**Re: Initial Submission Review:** Skydance Improvements Phase Two – Infrastructure Site Plan  
**Application Number:** DA-2283-02  
**Case Number:** 2023-6027-00

**RE: Review of Development Application DA-2283-02 Case Number 2023-6027-00 Skydance**

# SKYDANCE - PICADILLY RD, STREET D & STREET J INFRASTRUCTURE SITE PLAN

INFRASTRUCTURE SITE PLAN NO. 02

OVERALL

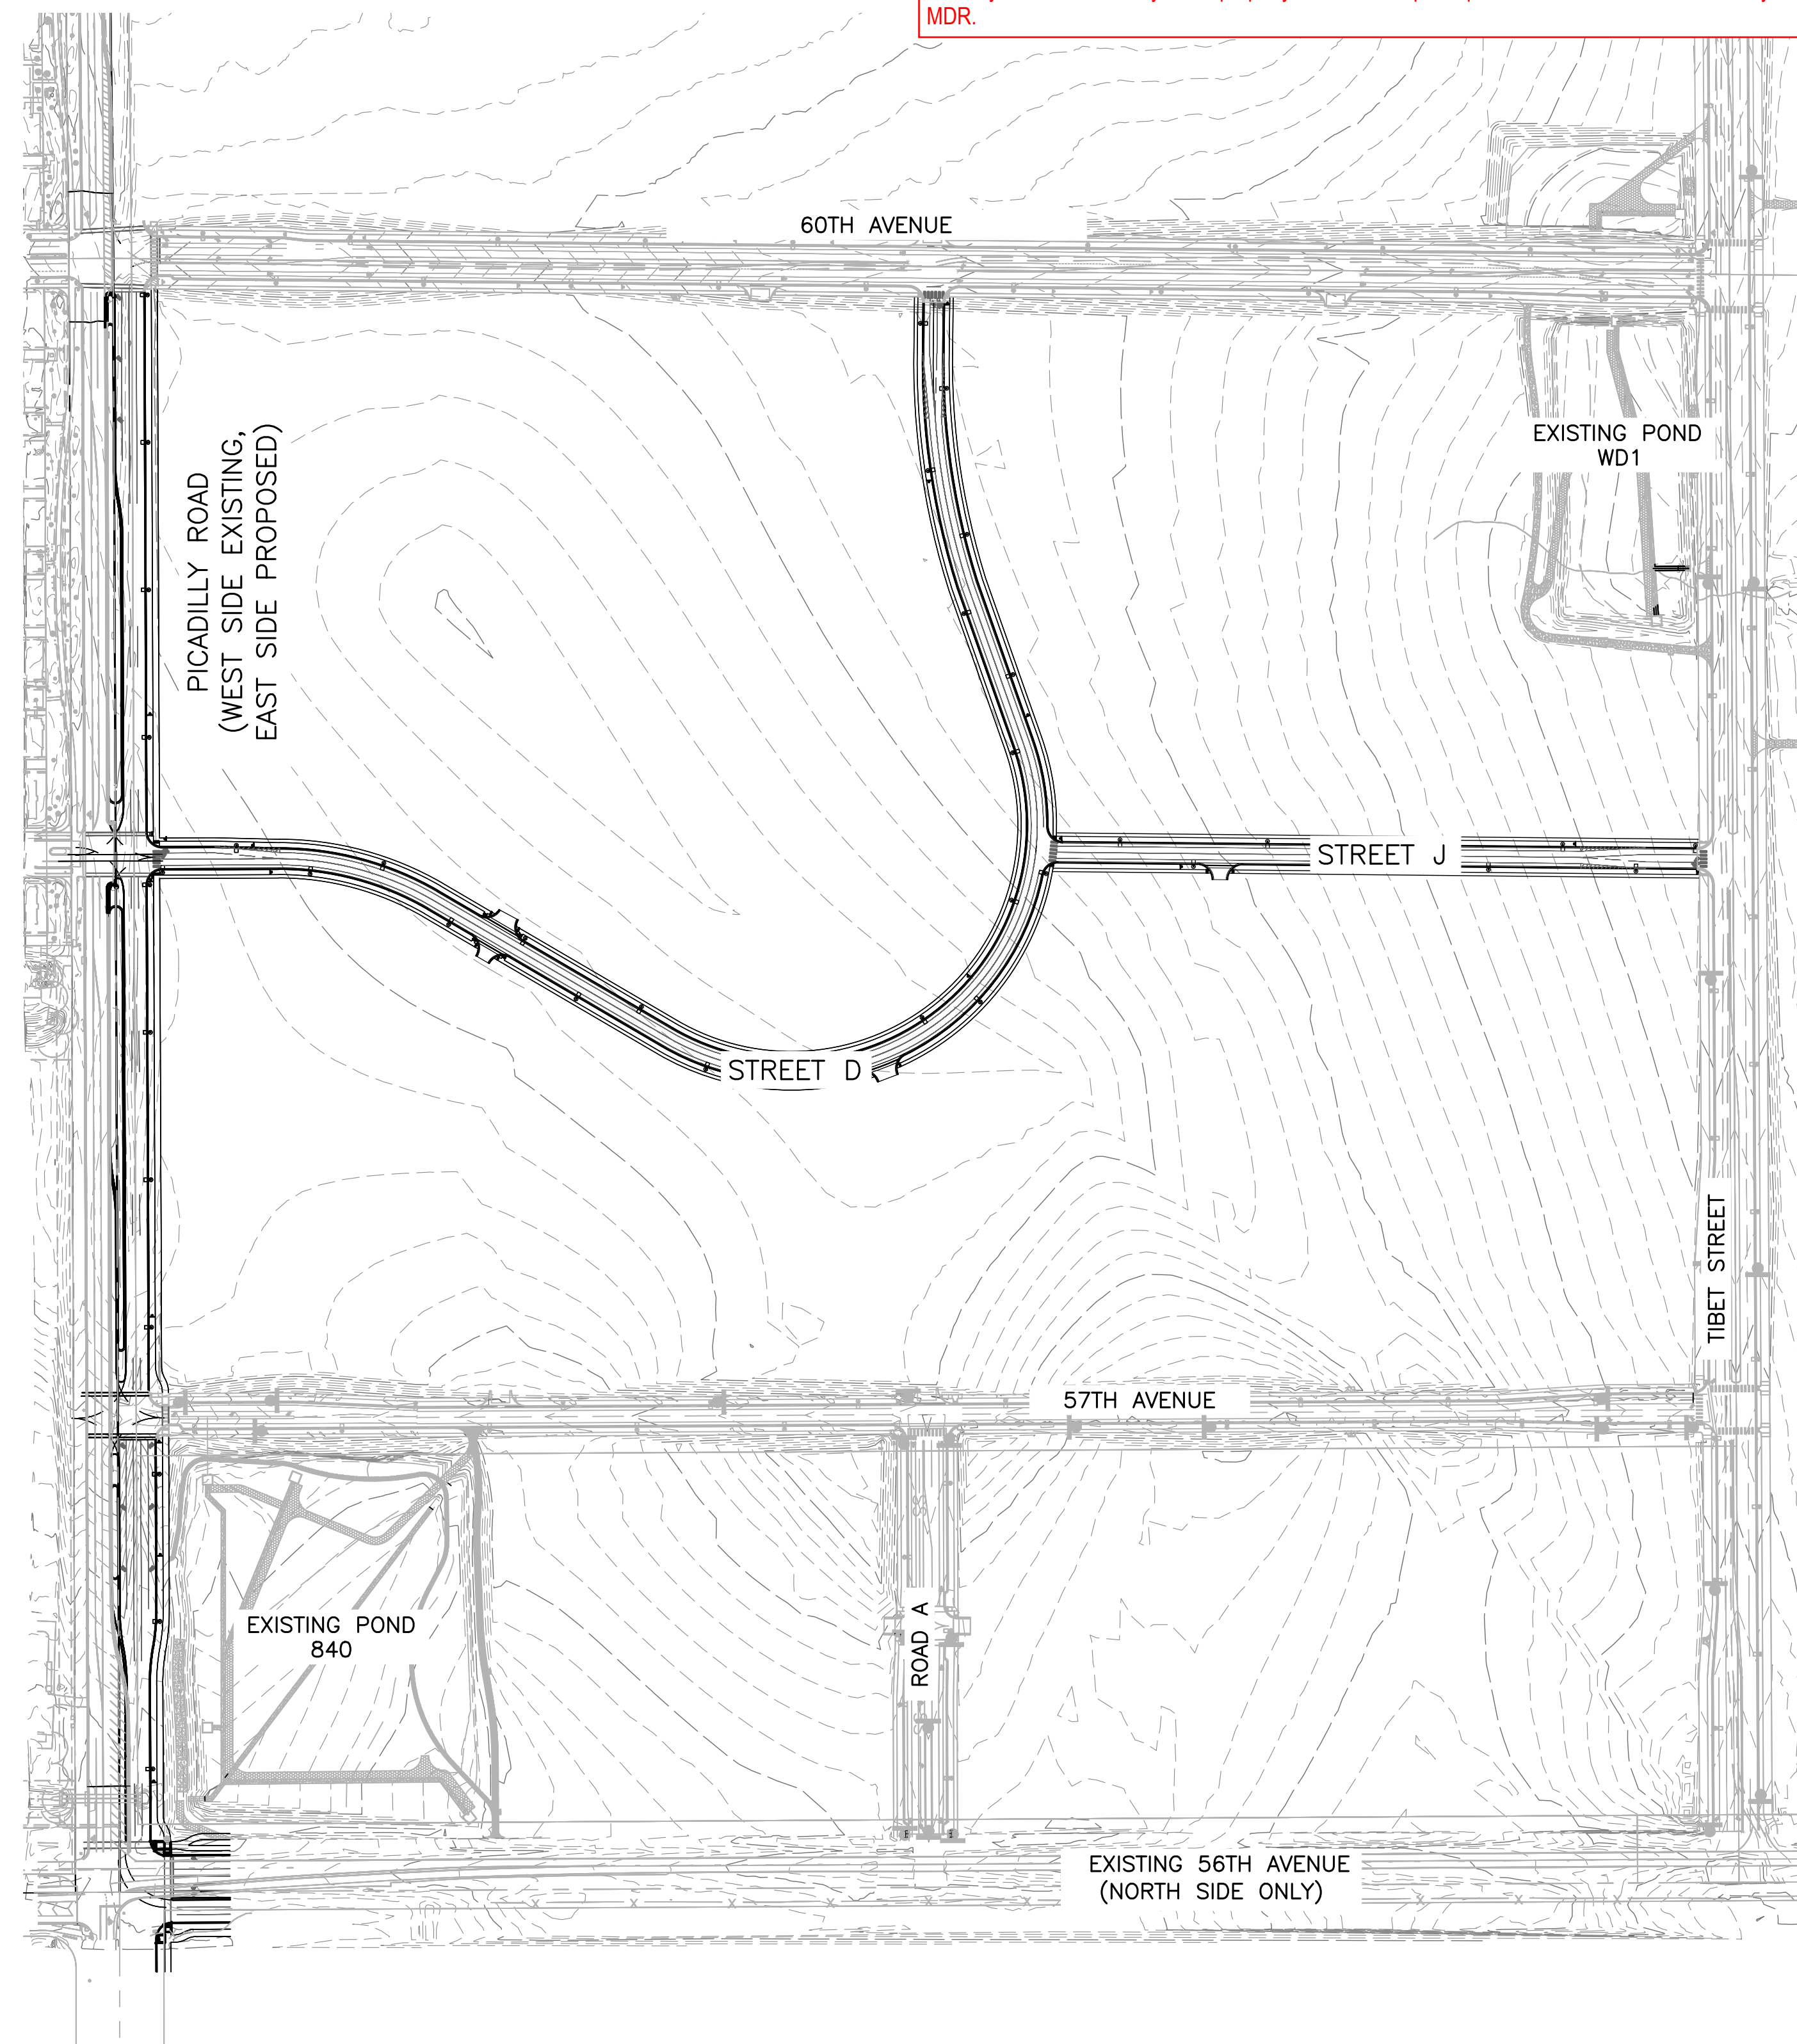
- All proposed roadway, drainage and utility improvements at the interface with E. 60th Ave are subject to those "existing" improvements as shown. At this time, the design and status of these E. 60 Ave improvements is unclear and are critical to understanding the real impacts of this ISP #2 as they relate to the adjacent property north of E. 60th Ave.

- Contours and roadway slopes are not labeled on a significant amount of this plan so it is difficult to determine the potential impacts on regional drainage as well as potential infrastructure transitions and connections with adjacent property.

- Stormwater and utility infrastructure is inconsistently displayed or not at all at critical interfaces with other property.
- Limits of construction at interfaces with existing/future/adjacent infrastructure is unclear.

- "Existing" contours within the area between E. 60th Ave, N. Picadilly Rd and Street D appear to create drainage basins that are not in conformance with the Skydance MDR. Because no interim swales, stormwater pipes with FES capture, or other drainage facilities are indicated for areas that will trap water, it is unclear whether current off-site runoff from the north will be adequately conveyed through N. Picadilly Rd and/or the Skydance property and to the required ponds in conformance with the Skydance MDR.

STREET-D

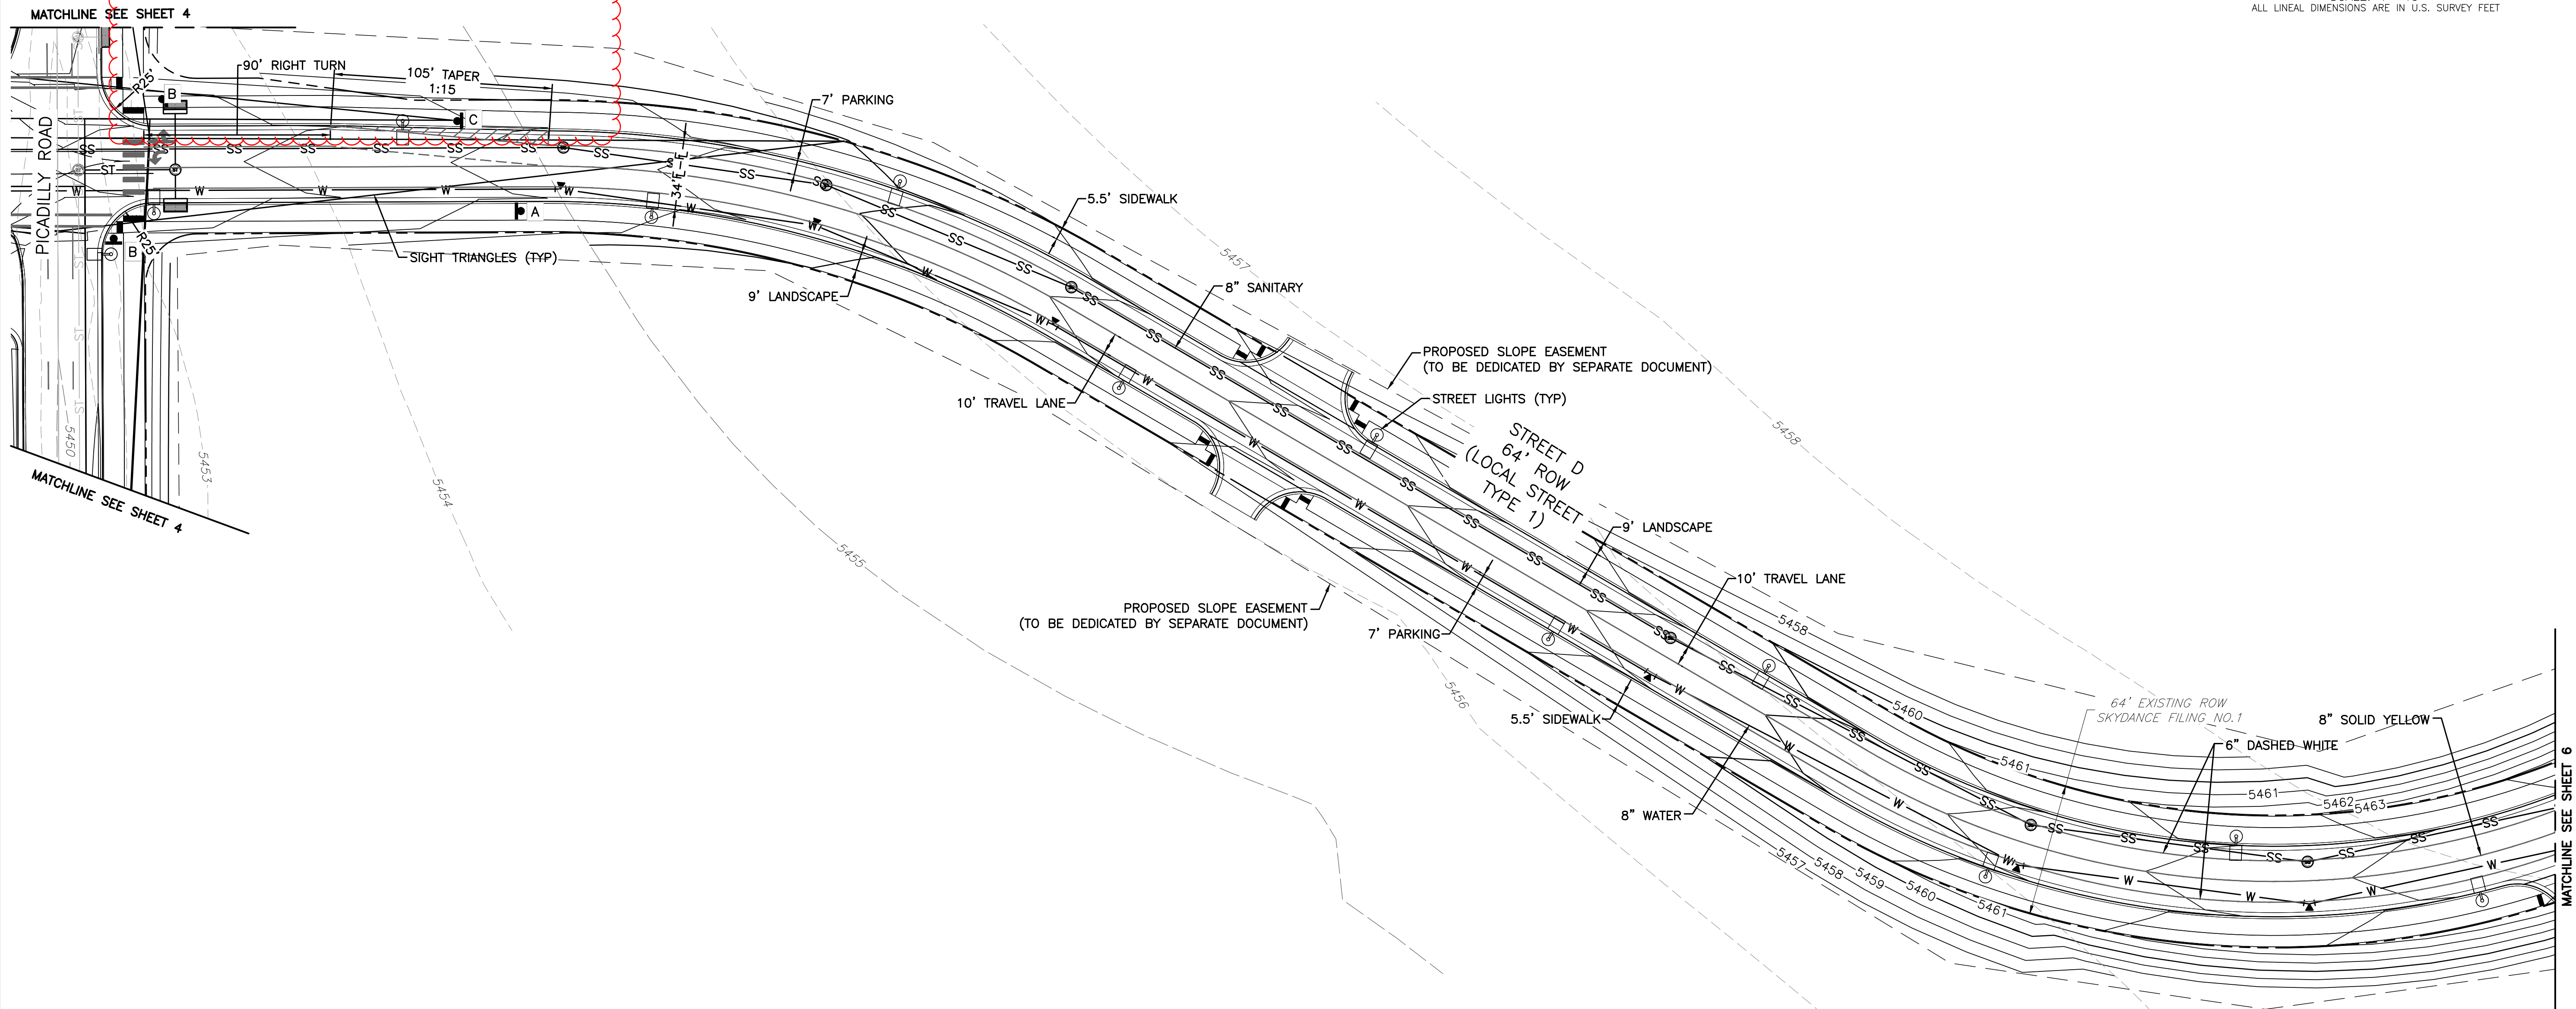
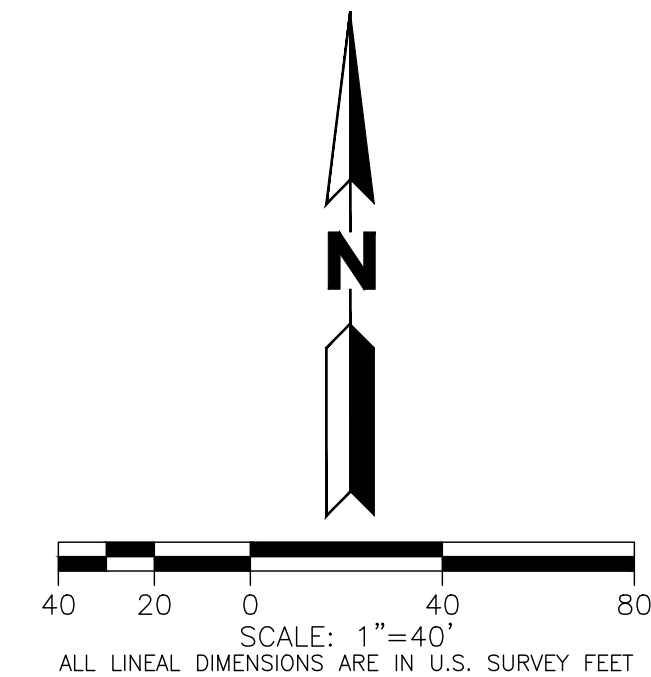
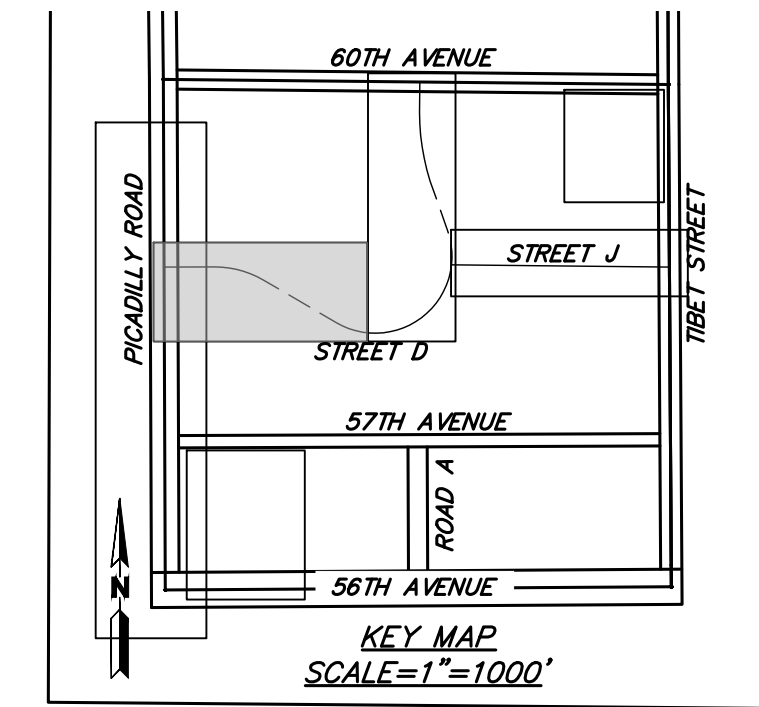
This area will trap stormwater runoff that will potentially include runoff from off-site property to north if E. 60th Ave is not already constructed. Currently it is not clear that this property will be adequately conveying said off-site runoff. (Typical throughout)
